# Product Change Notification

**TRIMPOT® TRIMMING POTENTIOMETERS**

## Bourns® Trimpot® Product Line Announces Models **3214** and **3224** Product Change

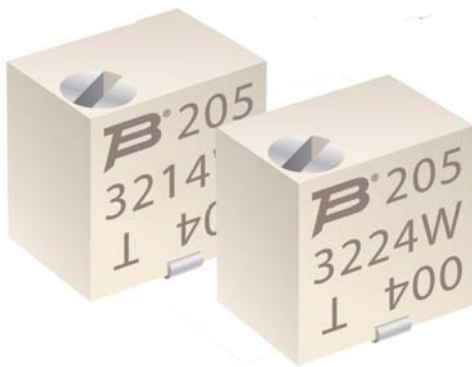
Bourns® Trimpot® Product Line has updated the material used for these models. This material is an engineered plastic that does not contain halogen compounds to assist in the retardation of flammability. These products are the first of many products that we will be converting to become “halogen free.”\*

Both plants (Taiwan and Costa Rica) will begin the conversion on April 1, 2011. The effective date code will read 114. This change does not affect form, fit or function of the product. There will be a color difference.
